Attachment A
Technical Specification
Page Revisions

Consolidated Edison Company of New York, Inc.
Indian Point Unit No. 2
Docket No. 50-247
June, 1989

FIGURE 3.8-1

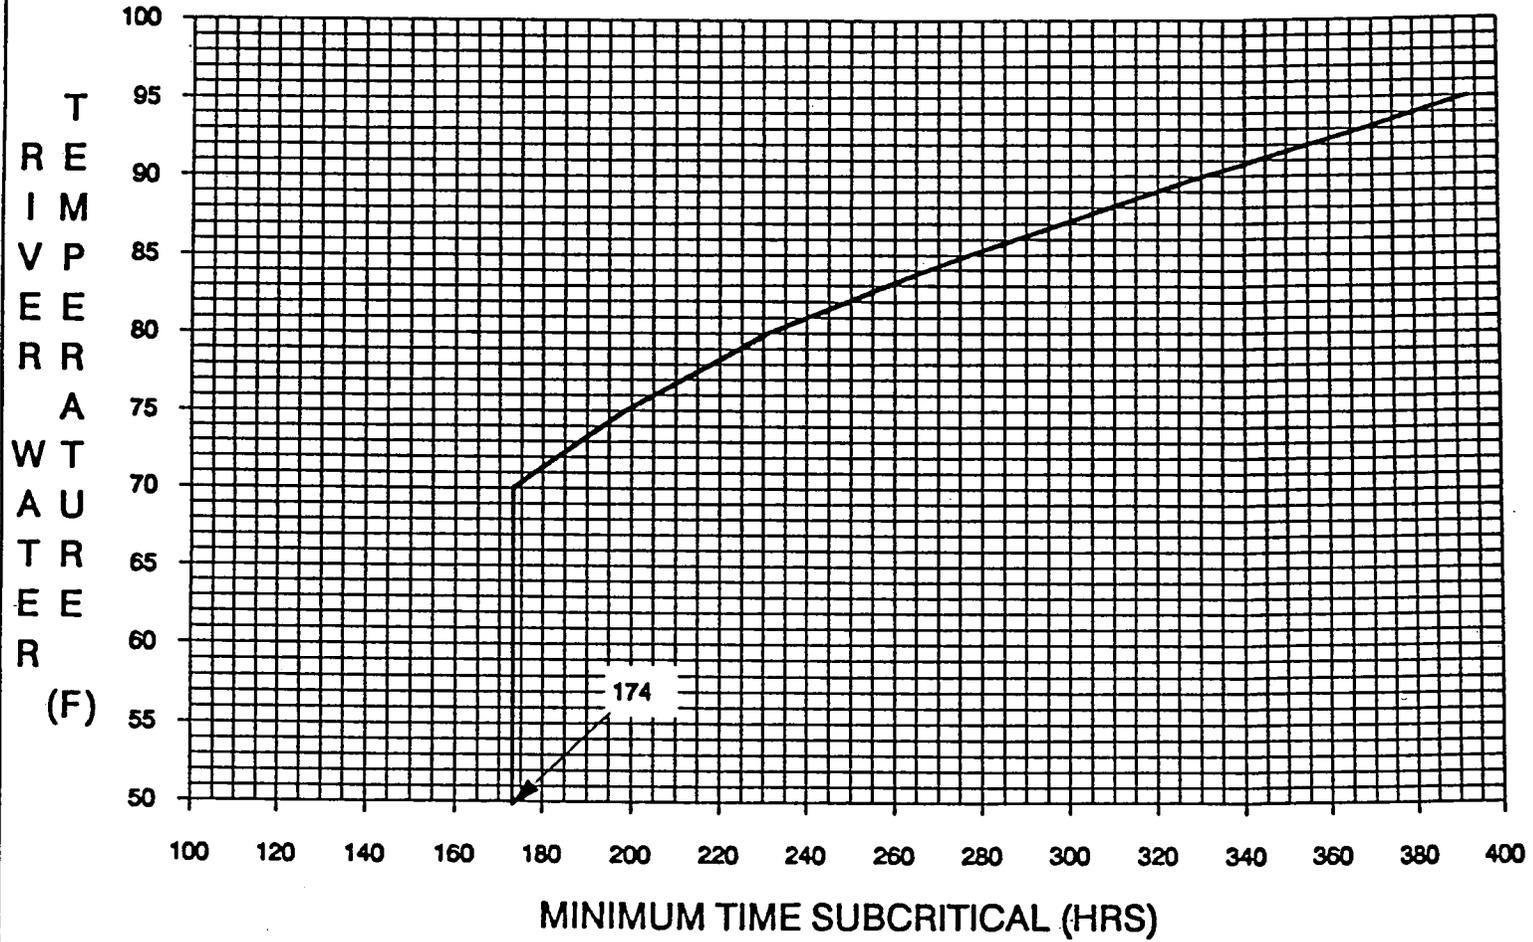
1. Specification 3.8.A above shall be met.
2. The minimum boron concentration shall be the more restrictive of either ≥ 2000 ppm or that which is sufficient to provide a shutdown margin $\geq 5\% \Delta k/k$. The required boron concentration shall be verified by chemical analysis daily.
3. Direct communication between the control room and the refueling cavity manipulator crane shall be available whenever changes in core geometry are taking place.
4. No movement of fuel in the reactor shall be made until the reactor has been subcritical for at least 174 hours or the more restrictive time period specified in Figure 3.8-1.

2. The spent fuel storage pit bulk water temperature shall not exceed 180°F. In the event the bulk water temperature increases above this value, all fuel additions to the spent fuel storage pit shall cease and immediate action shall be initiated to reduce the bulk water temperature to below 180°F.

Figure 3.8-2

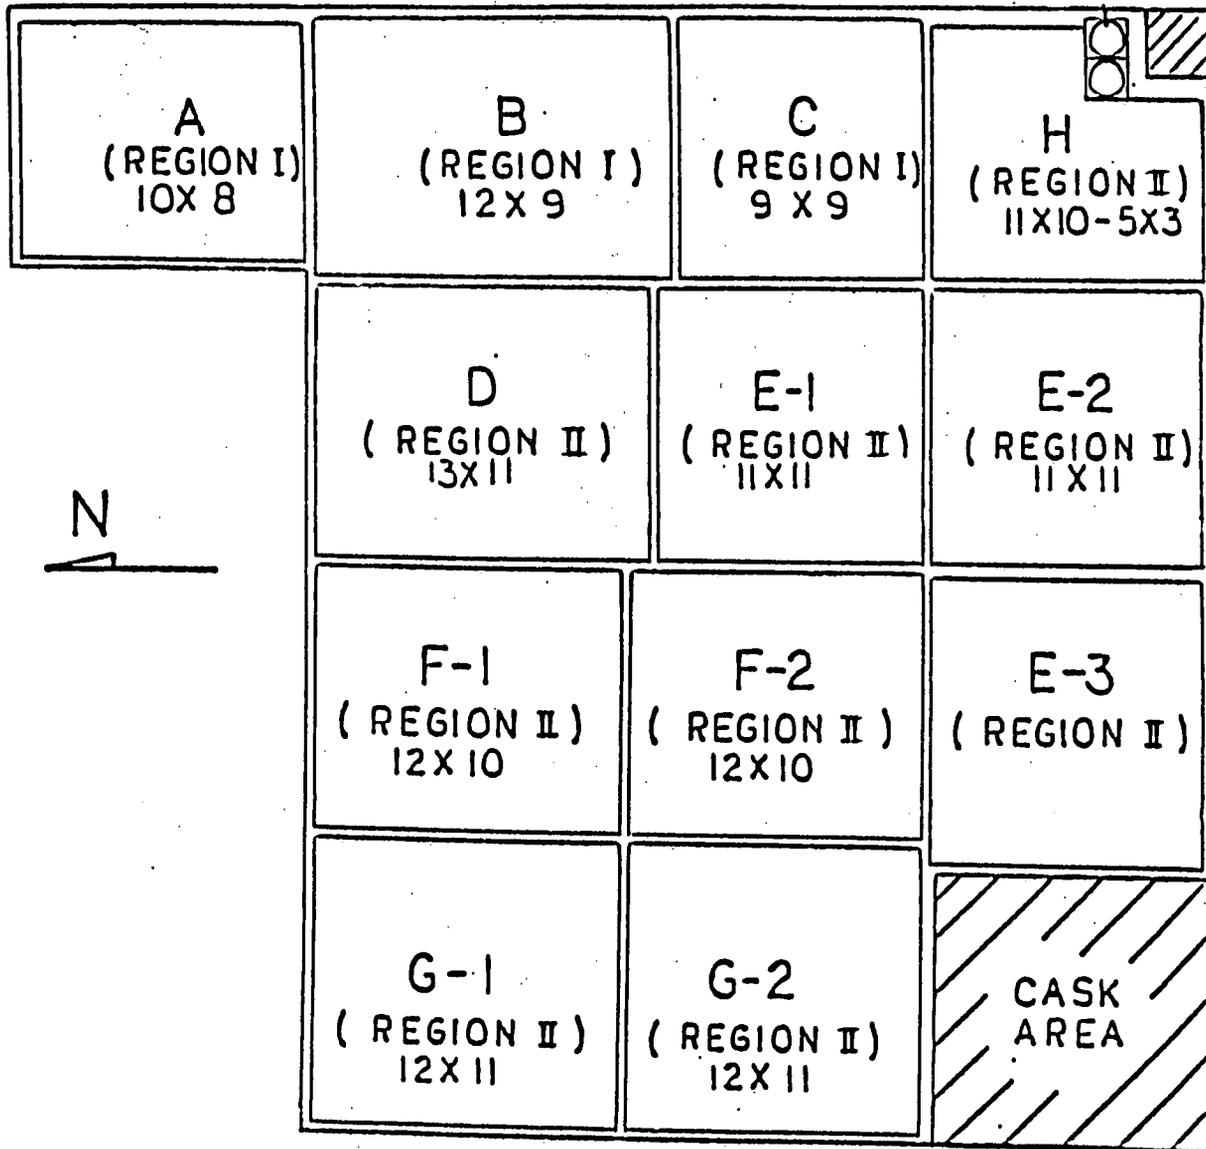
1. The spent fuel storage racks are categorized as either Region I or Region II as specified in Figure 3.8-2. Fuel assemblies to be stored in the spent fuel storage racks are categorized as either Category A, B or C based on burnup and enrichment limits as specified in Figure 3.8-3. The storage of Category A fuel assemblies within the spent fuel storage racks is unrestricted. Category B fuel assemblies shall only be stored in Region I or in a Region II spent fuel rack cell with one cell wall adjacent to a non-fuel area (a non-fuel area is the cask area or the area on the outside of a rack next to a wall). Category C fuel assemblies shall be stored only in Region I. The one exception to this shall be fuel assembly F-65 which shall be stored in Region I or in a Region II spent fuel rack cell with two cell walls adjacent to non-fuel areas.

Limiting Fuel Burnup
Versus
Initial Enrichment

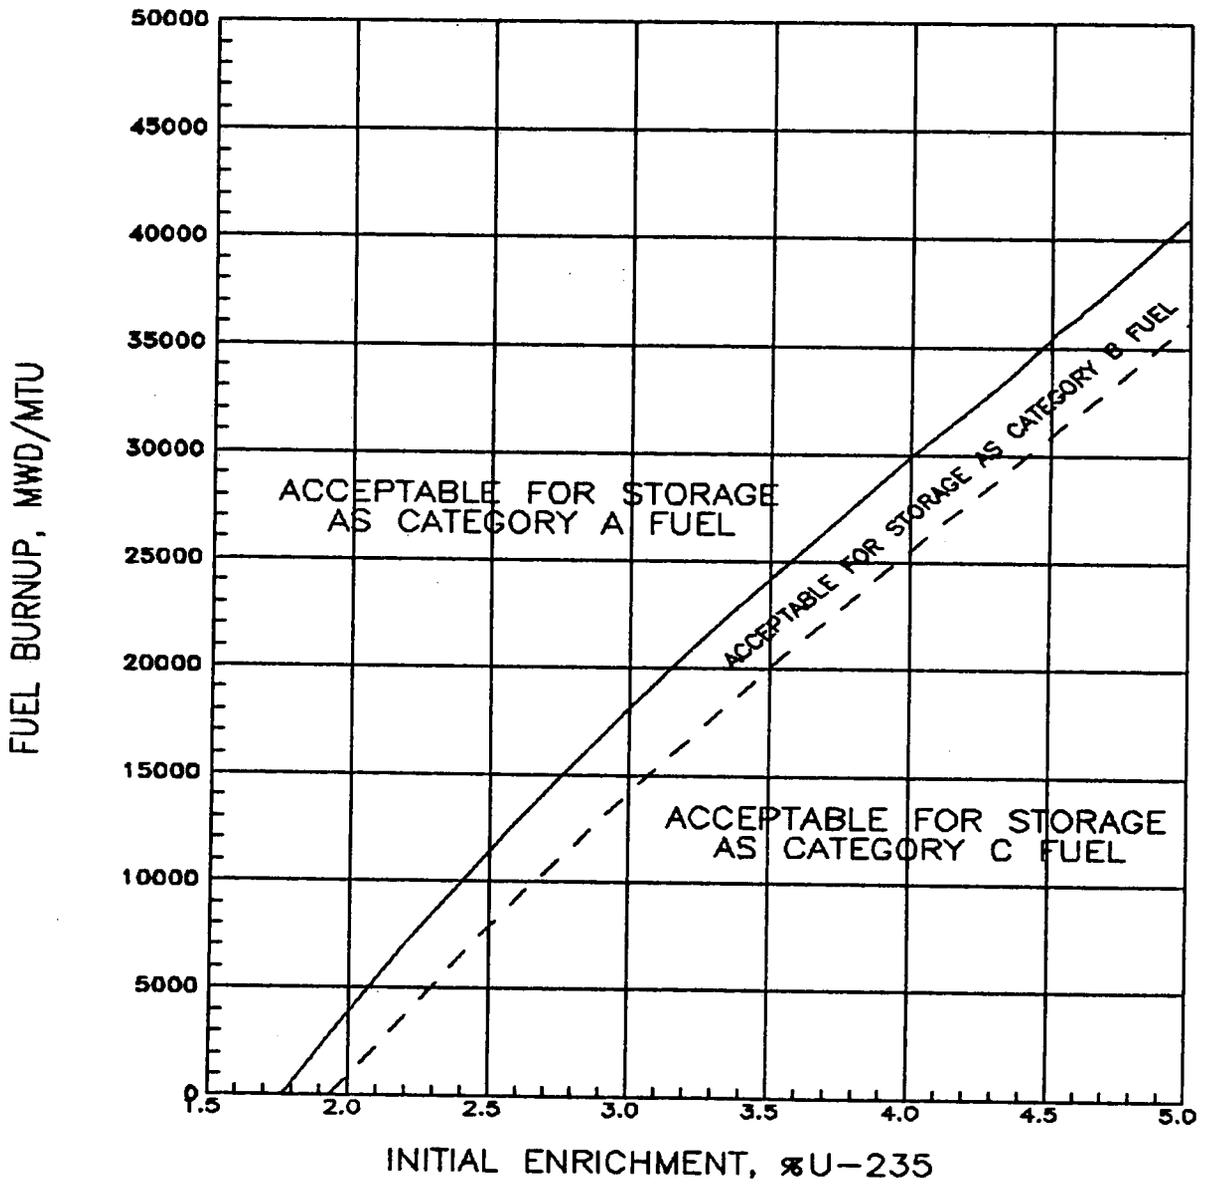
- 2.B. The spent fuel storage racks are designed and their loading maintained within the limits of Technical Specification 3.8.D.1, such that $K_{eff} \leq 0.95$ even if unborated water were used to fill the pit and with the fuel loading in the assemblies limited to 56.6 grams U-235 per axial centimeter of fuel assembly.
